**LOUISIANA  
POWER & LIGHT**

W3P84-1560  
3-A1.01.04  
Q-3-P43

SUBJECT: Waterford SES Unit 3  
Docket No. 50-382  
Further Information Related to  
Requests for Relief from Certain Technical  
Requirements of Appendix R to 10CFR50

FIGURE - 4

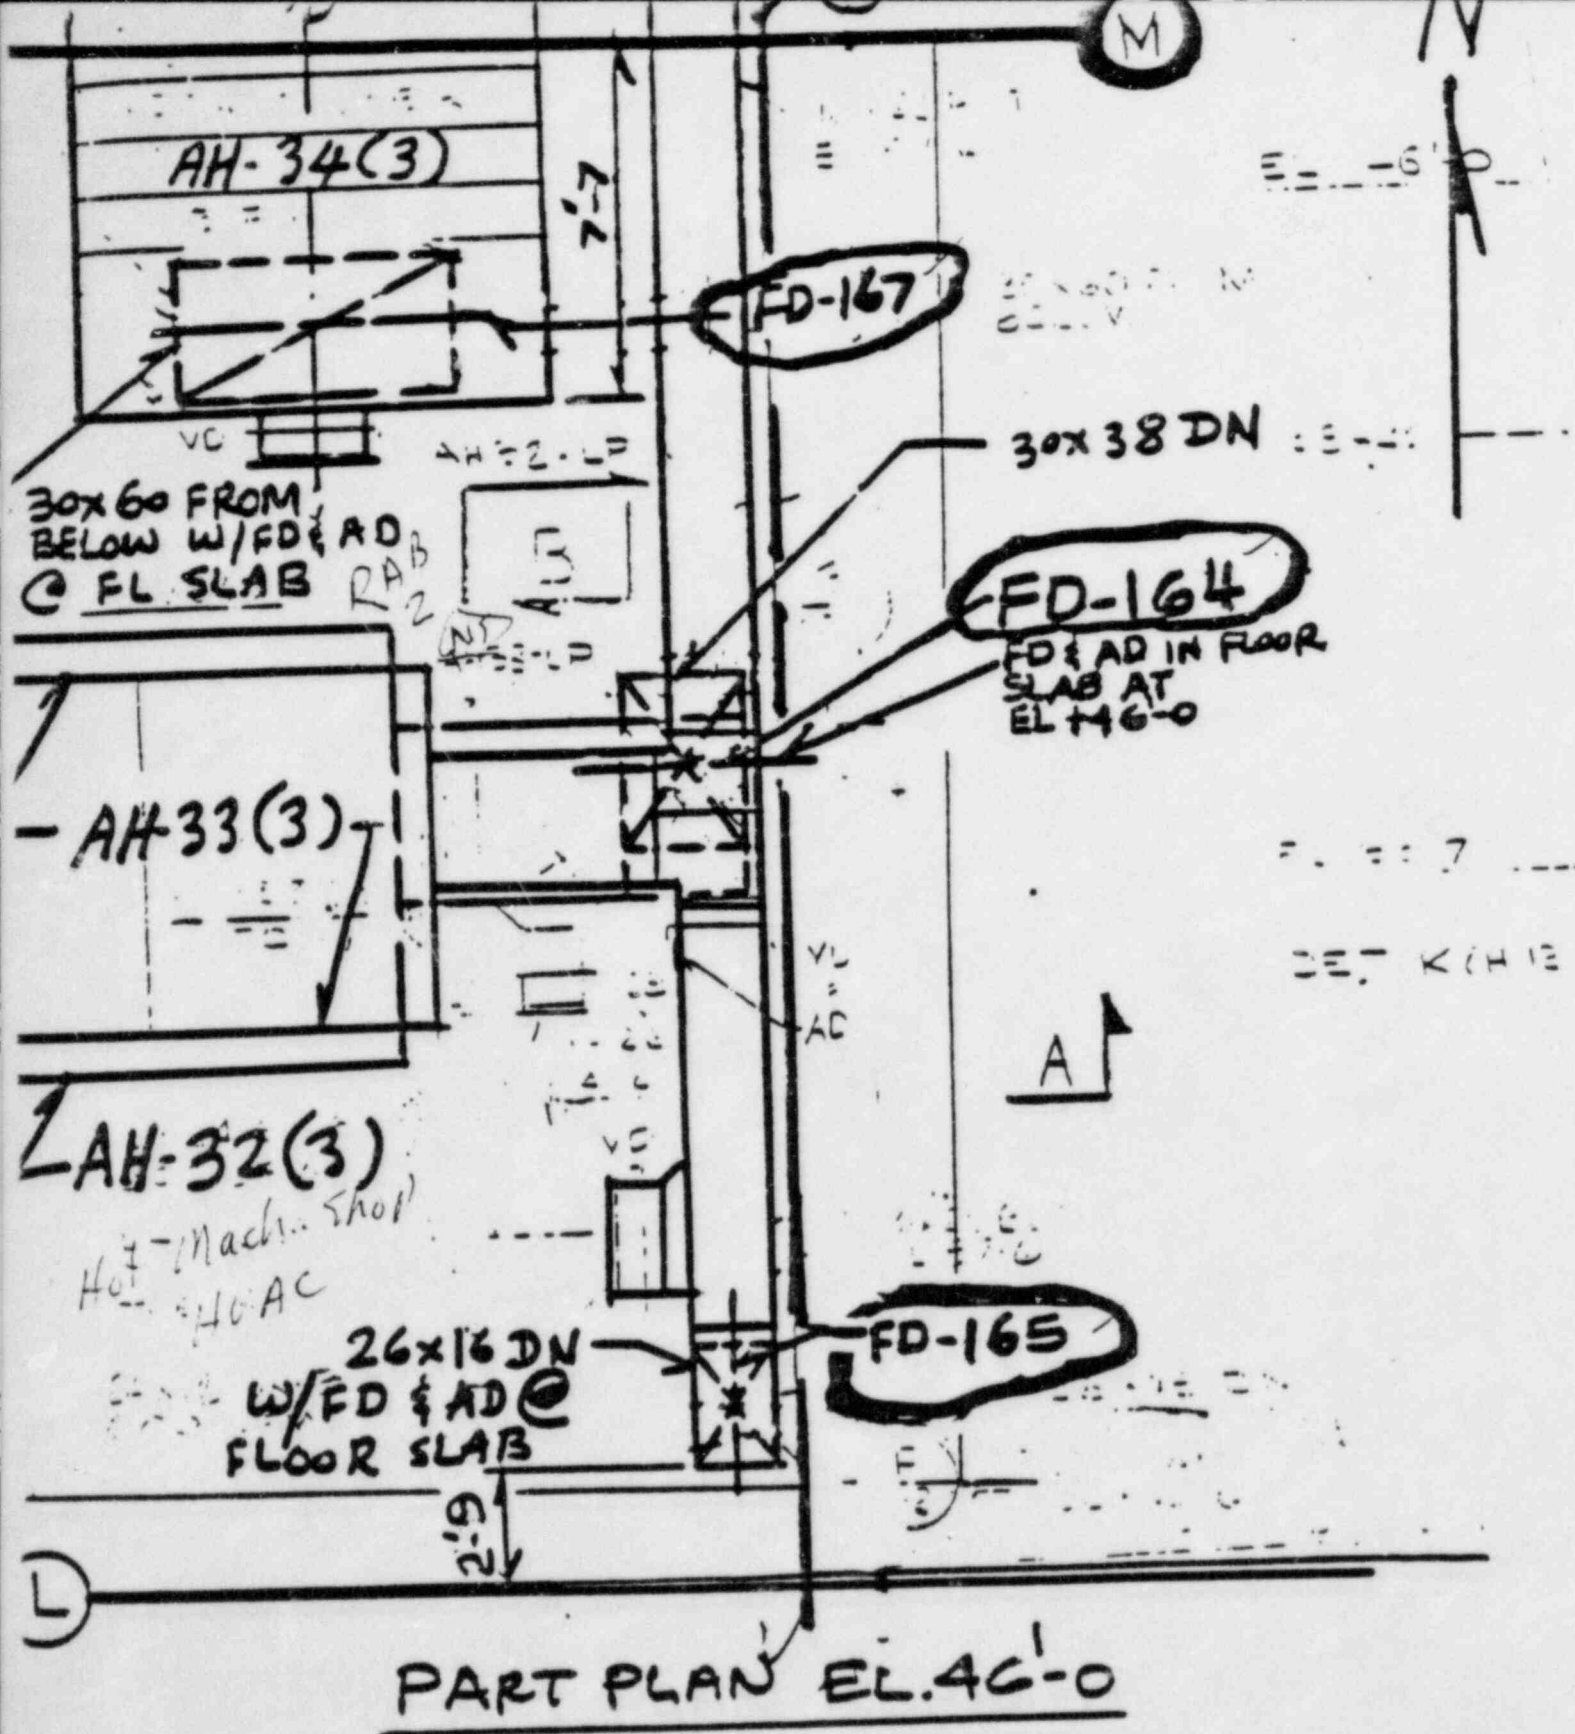
- (3) FD-163, 164, 165, 166 and 167 (refer to attached figures 1 through 5). These dampers are located in the floor of the hot machine shop HVAC Room (part of RAB 2) located at + 46' el. This room has ionization type smoke detection and is separated from the remainder of RAB 2 by a reinforced concrete wall having a 3-hour fire resistance rating with the exception of conduit penetrations and a non-fire rated personnel access door. The area below this floor is RAB 24 (hot machine shop) which also has ionization detection. These two rooms (RAB 24 and Hot Machine Shop HVAC Room) have no equipment required for safe shutdown. Based on our design in depth utilizing detection, suppression where needed, passive protection involving substantial fire resistance building construction, fire extinguishers and hose station protection and the fact these dampers are not essential since they separate rooms which have no safe shutdown equipment; the existing fire barrier afforded by these damper installations is considered adequate.

FIGURE 9

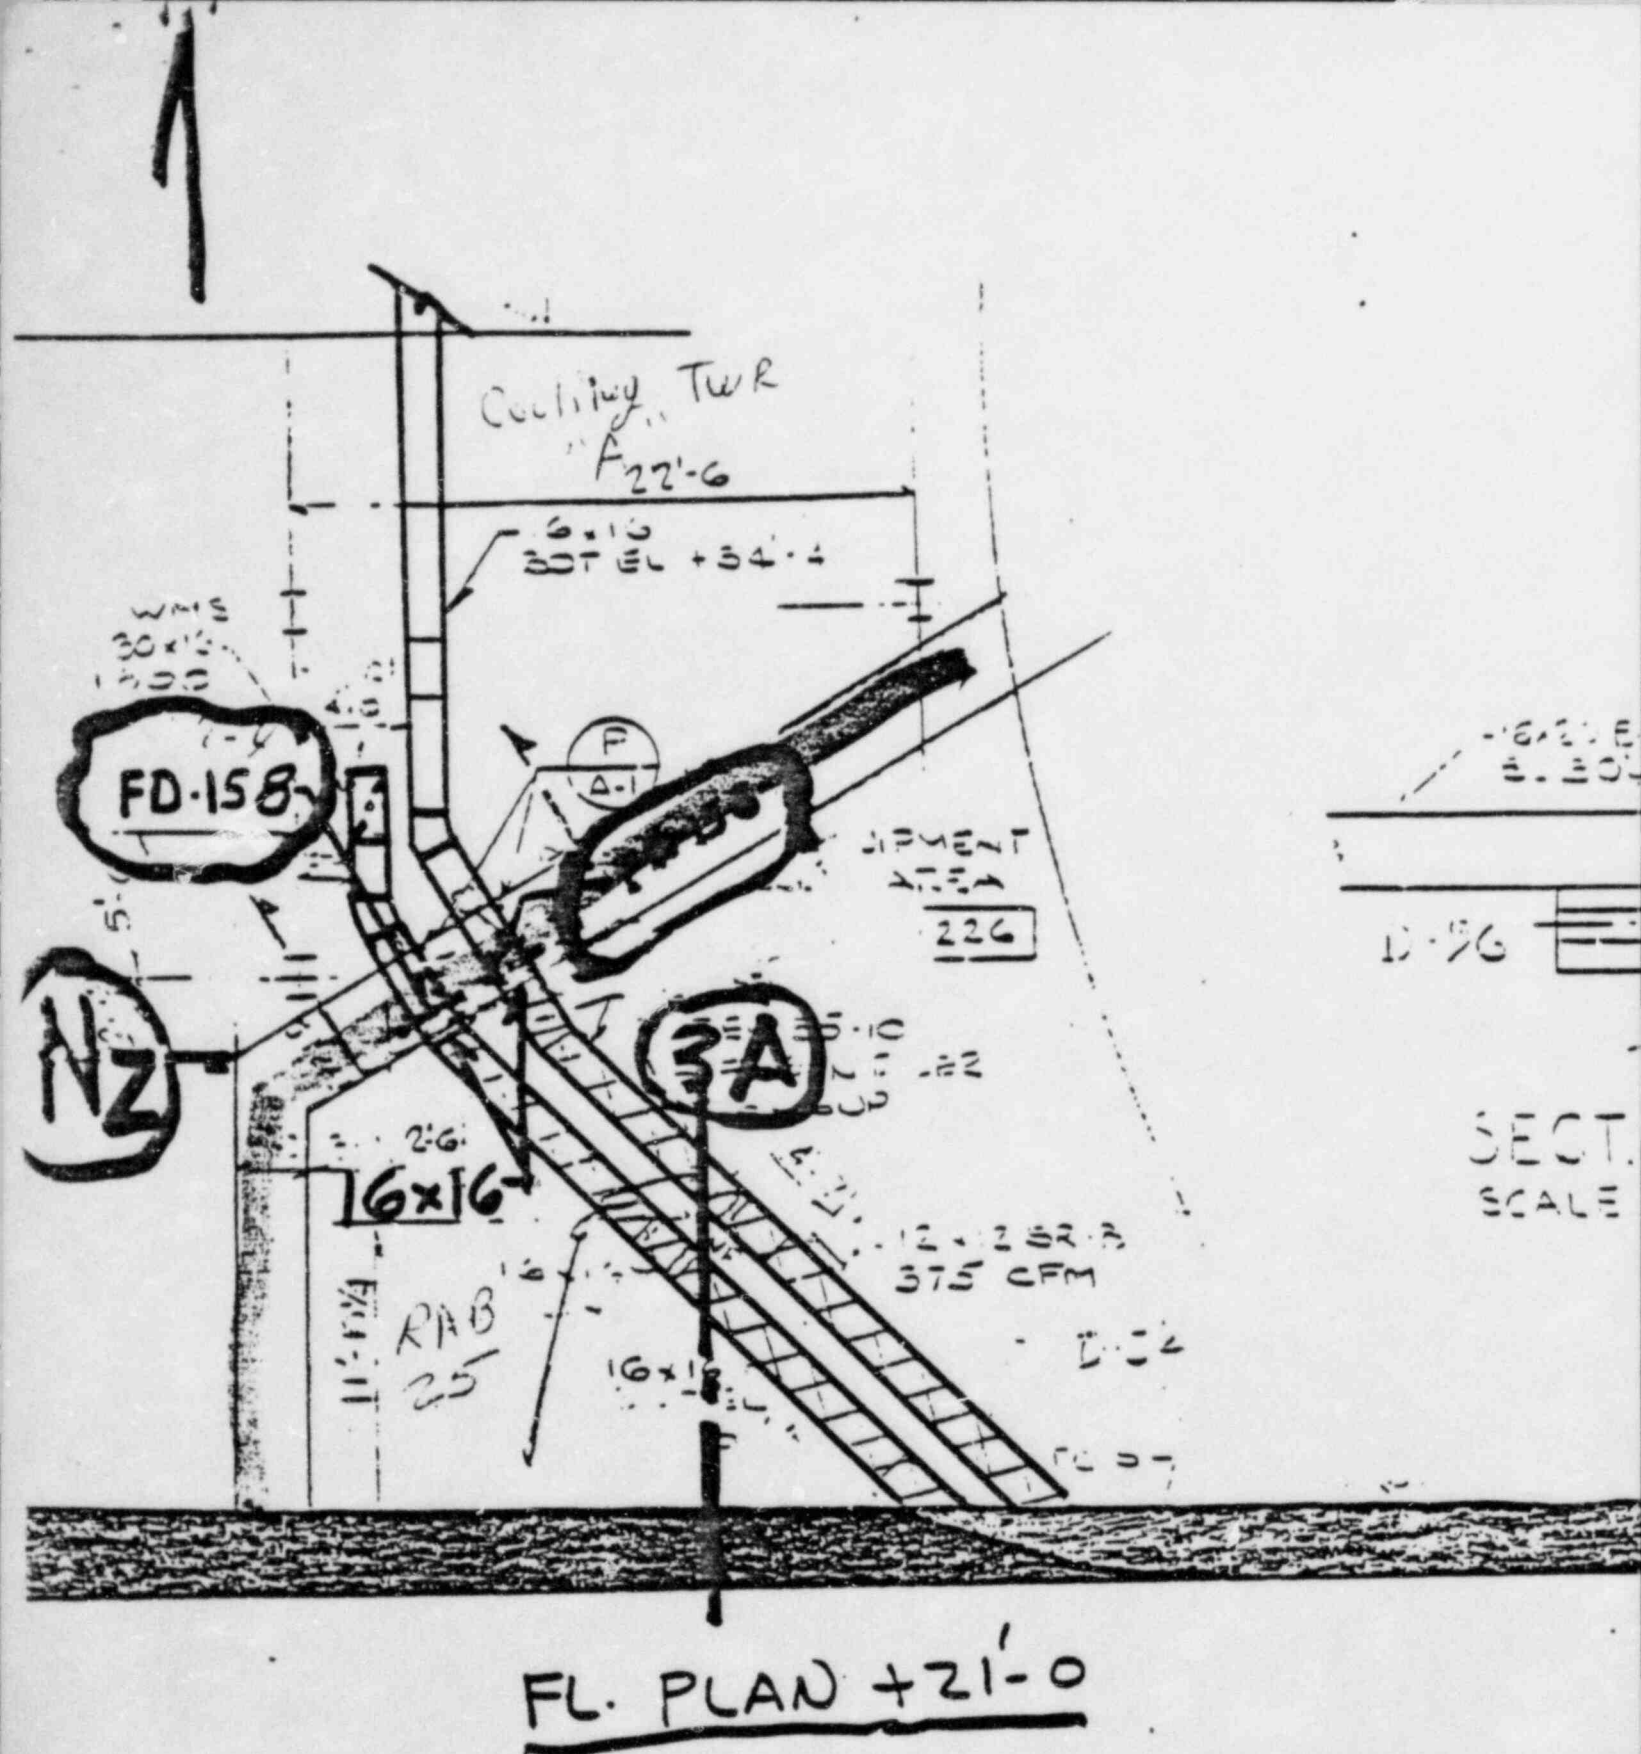
- (5) FD 156 and 158 (refer to attached figures 8 and 9). These dampers are located in the fire rated wall separating RAB 25 from cooling tower A. RAB 25 has ionization type detection and the duct in this area is seismically supported. The duct located in cooling tower "A" area is non-seismically supported. Cooling tower "A" is an open area with negligible combustibles. Based on our design in depth utilizing detection in areas of any combustibles, passive protection involving substantial fire resistive building construction, fire extinguishers and hose station protection and the fact that these dampers are not essential since they do not separate redundant safe shutdown equipment, existing fire barrier separation afforded by these dampers is considered adequate.
